**PLANNING COMMISSION
STAFF REPORT**

Date: June 8, 2023

Subject: Staff Report (For Possible Action): Case No. LDC23-00052 (Panda Express Variance) – A request has been made for a variance from the freestanding sign requirements of the General Commercial (GC) zone to: a) increase the number of allowed freestanding signs from one to two and b) increase the allowed sign copy area from 250 square feet to 500 square feet. The ±4.60 acre project site is located south of Sky Vista Parkway, ±182.9 feet east of its intersection with Vista Knoll Parkway. The project site is located within the General Commercial (GC) zoning district and has a Master Plan land use designation of Special Planning Area/Reno-Stead Corridor Joint Plan/General Commercial (SPA/RSCJP/GC).

Case No.: LDC23-00052 (Panda Express Variance)

Z1 DOUBLE FACE ILLUMINATED TENANT POLE SIGN
Quantity: One (1) Required

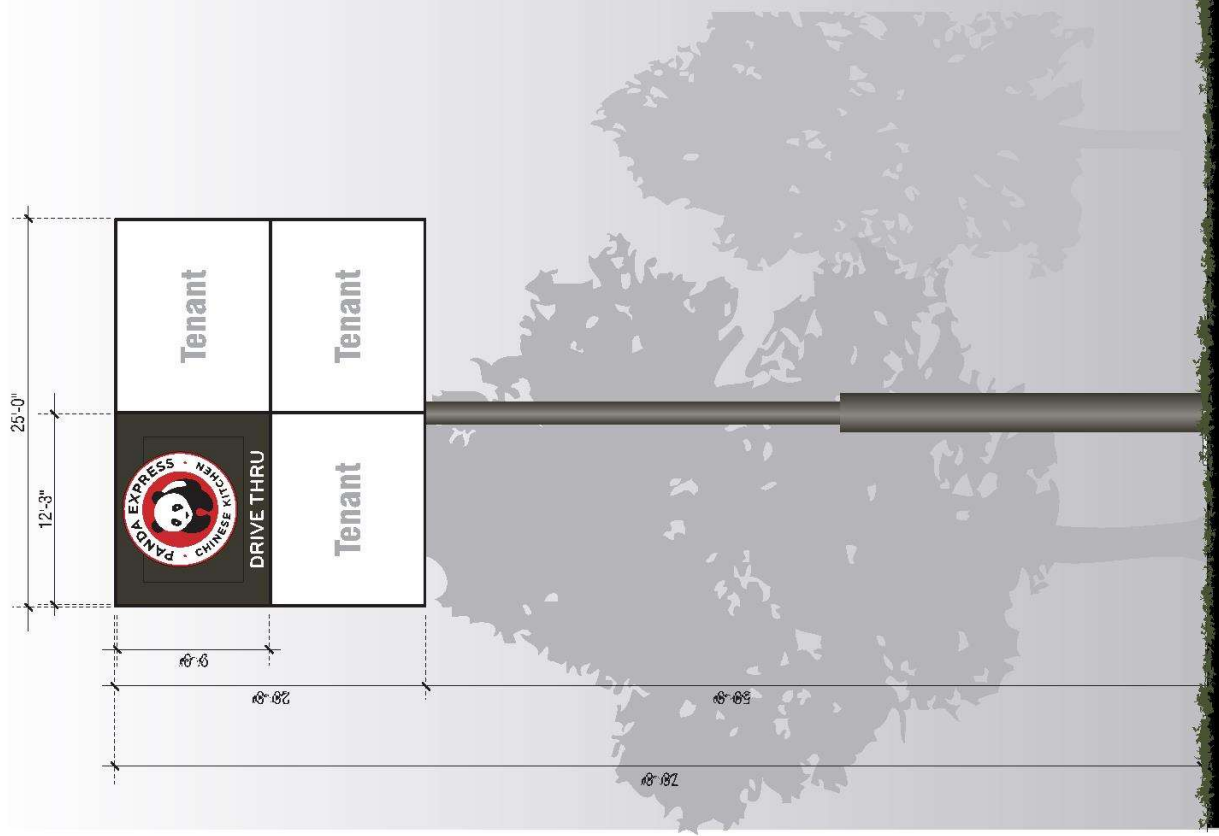
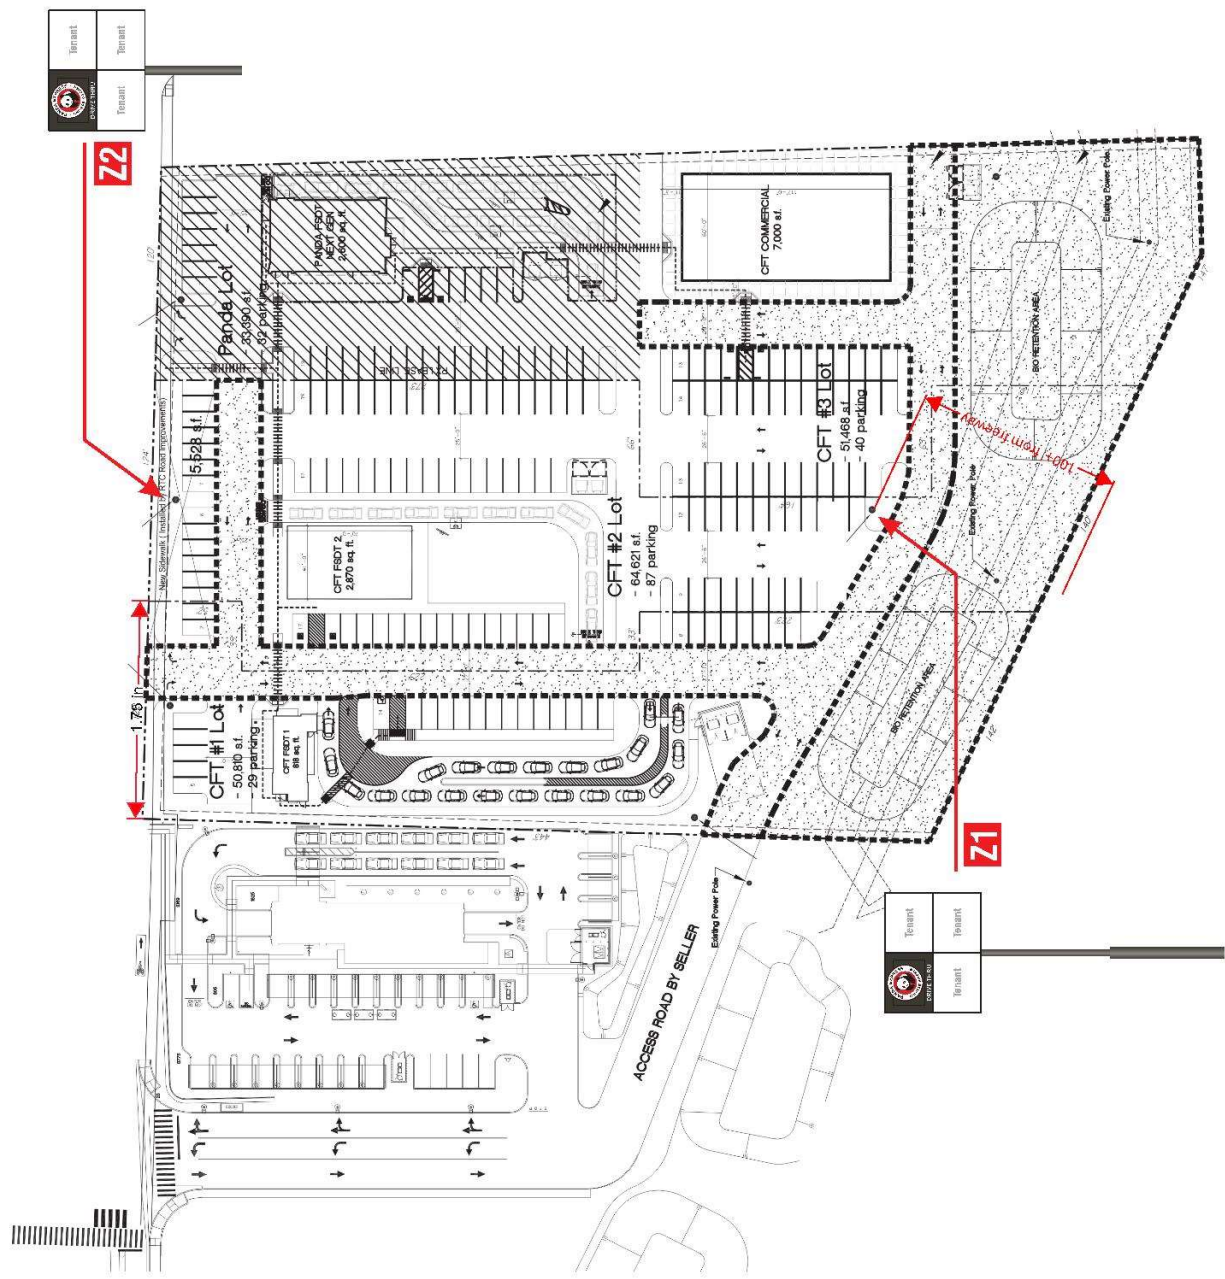
Compatibility with Surrounding Uses: The applicant proposes two pole signs: one at 70 feet in height and one at 40 feet in height. Each sign is proposed to have 500 square feet of sign copy area in an internally illuminated cabinet. The 40 foot sign would be located adjacent to Sky Vista Parkway while the 70 foot sign would be internal to the property, closer to the US-395 Highway (**Exhibit B**). Signs positioned within 100 feet of the highway right-of-way and visible from travel lanes of the highway are limited to 20 square feet. The proposed sign is located outside of this buffer zone.

The proposed signage has 500 square feet of copy area each, twice the allowed size of a sign normally allowed for individual signs in the GC zone on frontages posted 35 MPH. Comparably, the existing Walmart center sign across Sky Vista Parkway has 215 square feet of sign copy area and is 35 feet tall. The design of the sign does not appear to be in harmony with the aesthetic or identity of the proposed development (**Master Plan Policy C-SC.15**). Should the Planning Commission support the variance to increase the number of signs and increase the sign copy area, staff recommends **Condition No. 6** that requires a monument sign, where the width of the sign structure base is not less than 50 percent the width of the sign copy, and that the architecture of the sign structure be consistent with the architecture within the development.

5. Prior to the installation of the freestanding signs, the applicant shall have plans approved illustrating that the sign height is reduced to 35 feet from the top of grade at the base of the sign to the top of the sign copy.

6. Prior to the installation of the freestanding signs, the applicant shall have plans approved illustrating that a monument sign is proposed, where the width of the sign structure base is not less than 50 percent the width of the sign copy, and that the architecture of the sign structure is consistent with the architecture of the development.

1 70 FEET HIGH - NORTHBOUND 395 1/4 MILE AWAY
 SCALE: 1" = 200'-0"

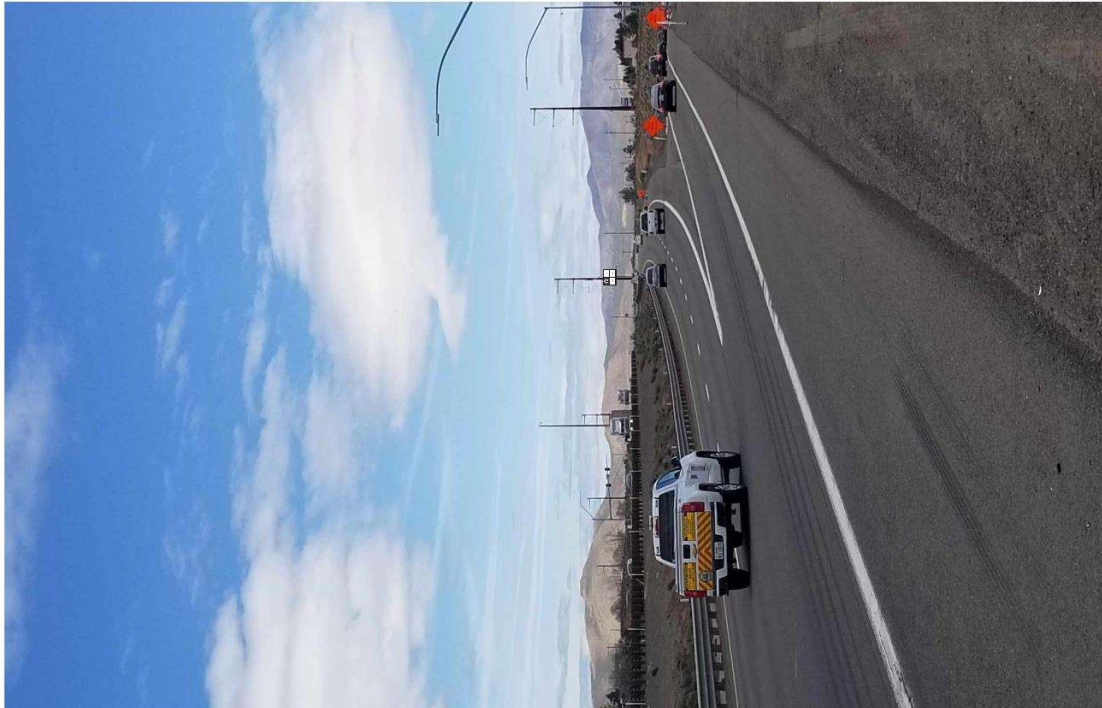
The proposed signs would be taller than any signs in the area and would be the only site within a mile that includes on-premises, freestanding signage oriented toward the highway (**Exhibit C**). The project site is generally at the same grade as the highway and adjacent neighborhood. The proposed 70 foot sign may negatively impact the privacy of existing residential uses within the immediate vicinity. Should the Planning Commission support the variance to increase the number of signs and increase the sign copy area, staff recommends **Condition No. 5** that would limit the sign height to 35 feet for both signs to be more consistent with sign height in the area and reduce the impact on adjacent residentially zoned property.

The applicant contends that the bend on US-395 at Lemmon Drive causes a condition where the sign is not visible from the highway and would result in misdirection and greater traffic on the surrounding roadway network. The Land Development Code specifically limits signs that are visible from the travel lanes of the highway when within 100 feet of the right-of-way. There is no exceptional undue hardship or practical difficulty based on the curvature of the highway, because the highway is not a street frontage for on-premises signs and the code has standards implemented to minimize visual pollution from these corridors.
